TEXAS UTILITIES GENERATING COMPANY

COMANCHE PEAK STEAM ELECTRIC STATION
Independent Assessment Program Phase 3
Cinched U-Bolt Testing & Analyses Program
Additional Information

ATTACHMENT 1

Revision to Item 2 of Reference 1.

FIGURE 9

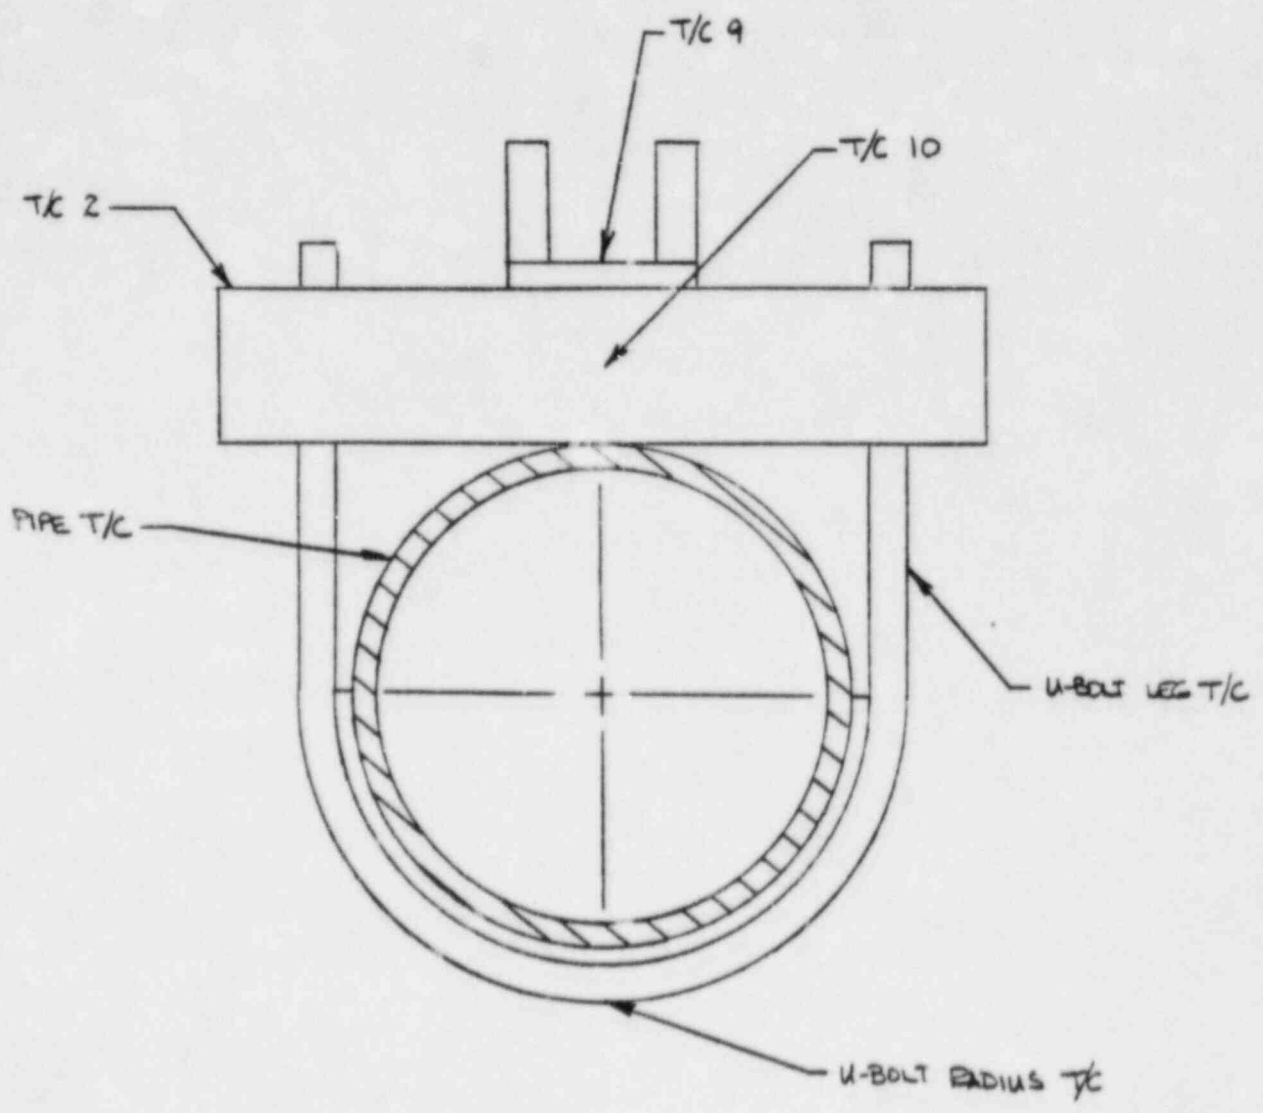
Thermocouples 2, 9 and 10 on the crosspiece reached temperatures of 129°F, 136°F and 144°F, respectively, at the end of Cycle 1. These are less than the equilibrium temperatures reached during the creep test. Figure 4 shows that temperatures had not leveled off. Refer to Figure 9 for location of thermocouples.
